N° 2015-086-A

Implementation of 300mm wafer diameter, capacity extension and conversion to halogen free mold compound for selected 600V C6 CoolMOSTM DPAK/IPAK products.

- Implementation of 300mm wafer diameter.
- Extension of wafer production capacity.
- Conversion to halogen free mold compound for DPAK/IPAK products at subcontractor Nantong Fujitsu Microelectronics Co., Ltd. (NFME), Nantong, China and IFX Malacca, Malaysia.

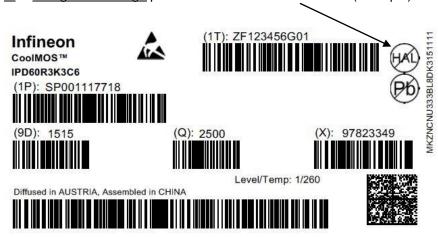
- <u>Internal traceability:</u> assured via baunumber, lot number and date code
- <u>2.</u> <u>External traceability:</u> new SP number for Halogen free products.
- 3. Lotnumber printed on Barcode Product Label:

VExxxxxx = IFX Villach, 200mm production

1Exxxxxx = IFX Kulim, 200mm production

2Fxxxxxx = IFX Dresden, 300mm production

VFxxxxxx = IFX Villach, 300mm production
